UNITED STATES DEPARTMENT OF THE INTERIOR
BUREAU OF OCEAN ENERGY MANAGEMENT
GULF OF AMERICA OCS REGION
NEW ORLEANS, LOUISIANA

SITE-SPECIFIC ENVIRONMENTAL ASSESSMENT
OF
DEVELOPMENT OPERATIONS COORDINATION DOCUMENT
NO. N-10256
FOR
BP EXPLORATION & PRODUCTION INC.
MARCH 13, 2026

BOEM received a total of 20 submissions through regulations.gov, which included a comment letter (i.e., Earthjustice et.al. – A) on behalf of Earthjustice, Sierra Club, Center for Biological Diversity, Healthy Gulf, and Turtle Island Restoration Network, along with the other 19 submissions providing references cited throughout the comment letter. An additional comment letter was received via postal mail on June 30, 2025. The June 30, 2025 letter (i.e., Earthjustice et.al. – B) included comments endorsed by 24,827 signatories urging BOEM to deny the proposed project. The letter also included 1,840 personalized comments (i.e., Earthjustice et.al. – C). Of those submissions, BOEM identified 84 unique and substantive comments that are addressed in the table below. All comments and attachments were included in the administrative record and considered during development of the SEA.

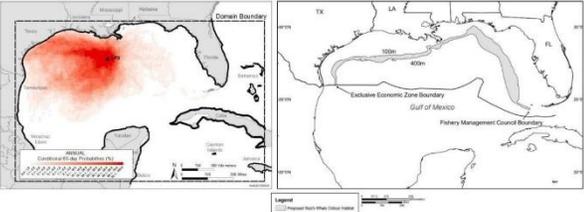
Earthjustice et.al. - A	BOEM-2025-0022-0031	<p>The act of drilling wells indisputably harms the surrounding marine environment. The noise from pile driving when installing platforms generates sounds with a "very high source level," and loud noises can disturb wildlife, cause physiological stress, and even impair hearing. Operating and servicing offshore platforms creates multiple sources of pollution, including inevitable smaller oil spills, debris, and other discharges that foul the nearby waters. Drilling requires considerable vessel and helicopter traffic that further floods the</p>	<p>These factors are considered in both the benthic biological review and Protected Species Step Down Determination review conducted by BOEM's Office of Environment prior to approving any proposed activities. Impact pile driving is not part of the proposed action in this DOCD. The proposed action and protocols found in the NMFS 2025 BiOp Attachments and Appendices (NMFS 2025a), as applicable, prevent or minimize potential effects. For example, the NMFS 2025 BiOp protocol A.6 Vessel Transit within the Rice's Whale Area as identified in the 2020 Biological Opinion's</p>

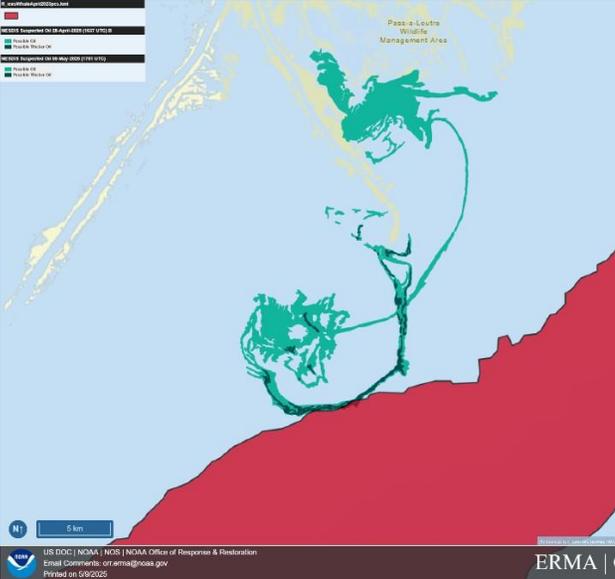
Commenter	ID Number	Comment	Response
		<p>marine habitat with noise and, in the case of the additional vessels, risks collisions with animals that can lead to injury or death. To assess what all that means for the immediate area, BOEM must bring to the fore information particular to the drilling location to better understand the site-specific effects. Yet the EIA demonstrates that BP's efforts to document effects for individual locations is insufficient, given the potential impact.</p> <p>That lack of effort may be a byproduct of BOEM's assumption, at least when considering potential harms to some species, that individuals are uniformly distributed across the Gulf. For example, BOEM concluded in a recent lease sale EIS that, for sea turtles, the "level of impacts" under multiple alternatives "would be the same" because of "the free-swimming ability and wide distribution of species." But readily available information demonstrates that where oil and gas activity occurs and which species it affects matter a great deal. The loggerhead turtle critical habitat designation discusses different habitat types critical to continued existence of loggerheads, including Sargassum habitat in the Gulf. Furthermore, the Gulf of Mexico Fishery Management Council's most recent review of Essential Fish Habitat (EFH) designations contains species descriptions, maps of EFH, and discussions of the underlying importance of different habitat types and different locations.</p>	<p>Reasonable and Prudent Alternative (2020 RWA) requires vessel restrictions in the event any service vessel transits the Rice's whale area to get to the project area. The NMFS 2025 BiOp A.2 Marine Debris Protocol is designed to prevent or substantially reduce accidental marine debris, thereby preventing or substantially reducing risk to protected species. Further, the NMFS 2025 BiOp A.3 Vessel Strike Avoidance and Injured and/or Dead Aquatic Protected Species Reporting Protocols require monitoring during transit and maintaining a separation distance while underway if marine mammals are detected. See response to BOEM-2025-0022-0030 for additional information on ESA compliance.</p> <p>While individual marine mammals or sea turtles may be attracted to offshore structures, it is unlikely that high levels of species aggregations would occur at this specific site. Sea turtles are distributed throughout the entire GOA, and are highly migratory; individuals migrate into nearshore waters as well as other areas of the GOA, North Atlantic Ocean, and Caribbean Sea. Rice's whale critical habitat is currently proposed by NMFS in the northern Gulf from the 100 m (328 ft) to 400-m (1,312 ft) isobath, which is not considered ultra-deep waters. Manatees would also not be expected in ultra-deep waters. Most other marine mammal species regularly found in the GOA have wide-ranging distributions throughout and outside the GOA.</p> <p>The project area for the Proposed Action overlaps with Essential Fish Habitat for a variety of highly migratory fishery species. These species have a wide range of EFH within the GOA. For some, their EFH also extends into the Caribbean and/or up the U.S. Atlantic Coast. The oil and gas EFH consultation applicable to the Proposed Action can be found at https://www.boem.gov/regions/gulf-america-ocs-region/oil-and-gas-efh-consultations. The benthic</p>

Commenter	ID Number	Comment	Response
			<p>biological review conducted by BOEM's Office of Environment prior to approving any proposed activities accounts for adopted conservation recommendations resulting from the 2022 EFH consultation.</p>
<p>Earthjustice et.al. - A</p>	<p>BOEM-2025-0022-0032</p>	<p>Ultra-deepwater drilling in the Gulf threatens sensitive deep-sea ecosystems and marine life, including endangered species. Among the species at risk are the endangered Kemp's ridley sea turtles, which rely on the Gulf's waters for feeding and nesting. The critically endangered Rice's whale inhabits the waters of the Gulf along the continental shelf break. The fragile deep-sea coral communities, which provide essential and delicate deep-sea habitats, will be harmed and were severely damaged by the BP oil spill. The disturbance and potential oil spills from drilling can devastate these delicate deep-sea ecosystems, leading to long-term impacts on biodiversity.</p>	<p>These factors are considered in both the benthic biological review and Protected Species Step-Down Determination review conducted by BOEM's Office of Environment prior to approving any proposed activities.</p> <p>Rice's whale critical habitat is currently proposed by NMFS in the northern Gulf from the 100 m (328 ft) to 400-m (1,312 ft) isobath which is not considered ultra-deep waters, as noted above in the response to BOEM-2025-0022-0030.</p>

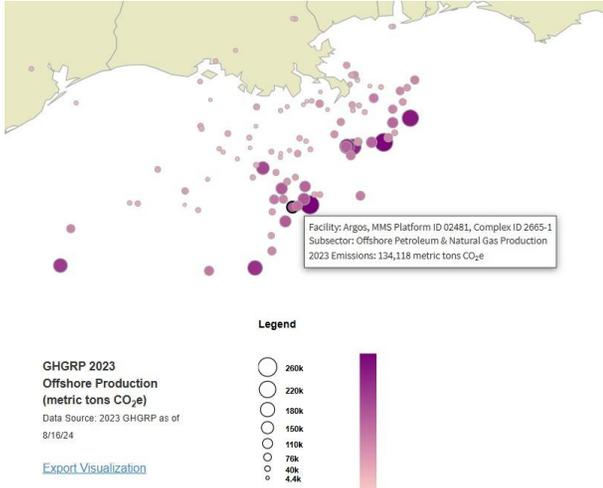
Earthjustice et.al. - A	BOEM-2025-0022-0063	<p>BP’s proposed DOCD states that BP drilled exploratory wells elsewhere in Keathley Canyon, on Block 336. The DOCD acknowledges that these wells have not yet been plugged, and states that the wells “will be temporarily abandoned and a well cap will be installed on the wellhead.” BOEM should not approve the DOCD unless and until BP permanently plugs these wells. Unplugged, temporarily abandoned, and improperly plugged wells are also prone to leaking and blowouts.</p> <p>For example, the 2010 Macondo deepwater well blowout, which caused the Deepwater Horizon oil</p>	<p>Operators may request extensions to the regulatory timeframes for decommissioning, which BSEE has authority to grant due to any individual or combination of factors, as discussed in Appendix C.1 of the 2025 GOA PEIS. Even when BSEE concurs that a well may be useful and capable of producing in paying quantities, companies are informed that they may still be required to ensure the well is secured and that producing zones are isolated to prevent potential safety and environmental impacts.</p> <p>Regarding idle structures, BSEE developed NTL No. 2018-G03 to clarify when the Bureau may deem</p>

Commenter	ID Number	Comment	Response
		<p>spill—one of the largest marine oil spills in the history of the oil industry—occurred during temporary abandonment activities. Decisions to cut corners in the plugging process (including, inter alia, using only one cement barrier and failing to follow industry standards in cementing the casing) may have contributed to the well’s failure. Aging wells are particularly susceptible to oil spills or other accidents. For example, 30 percent of offshore oil wells in the Gulf experienced well casing damage in the first five years after drilling, and damage increased to 50 percent after 20 years. Wells that have been temporarily abandoned for a long period are particularly concerning, as “[e]ntering these wells is difficult due to the uncertainties related to the conditions of the barriers and unanticipated well pressures.” Yet the number of temporarily abandoned wells has ballooned in recent years, and “[u]nless this backlog is reduced, the probability of blowouts from these wells will increase.”</p> <p>Methane leaks from unplugged and temporarily plugged wells are also of concern. For example, a study from the North Sea found that 65 percent (28 out of 43) of decommissioned offshore wells leaked gas into the water column and represented a major source of methane in the sea.</p>	<p>infrastructure “no longer useful for operations” and “not capable of oil, gas, and sulfur production in paying quantities” and the associated timeframes for decommissioning work. The NTL also includes guidance for the submittal of supporting documentation for review and concurrence. Operators are required to perform pollution and safety system inspections throughout the life of all platforms, including idle platforms. Safety and environmental-compliance inspections are maintained on idle infrastructure, prior to and after issuance of BSEE orders. While there is a potential for delayed decommissioning, the analysis presumes, as is reasonable, that the infrastructure will be decommissioned according to the regulations.</p> <p>See response to BOEM-2025-0022-0061 regarding decommissioning trends. Chapter 3 and Appendix C of the 2025 GOA PEIS highlight the substantial decommissioning of wells and platforms over the last 20 years.</p> <p>Particularly for deepwater, where this project is proposed, it is unlikely that low-level chronic leaks of methane from decommissioned wellheads would reach the surface. However, BOEM has considered the potential risk that methane leakage from abandoned oil and gas wells could pose to marine life and currently has a study underway to examine decommissioned wells to determine if any leaks could be substantial enough to emit air pollution at the sea surface, affect water quality, or have any other potentially notable environmental effects, i.e., NSL GM-22-01, at https://www.boem.gov/sites/default/files/documents/environment/environmental-studies/GM-22-01_1.pdf.</p> <p>Although research is limited, risks to marine organisms could arise from the chemical interactions of methane upon entering the water column, including microbial</p>
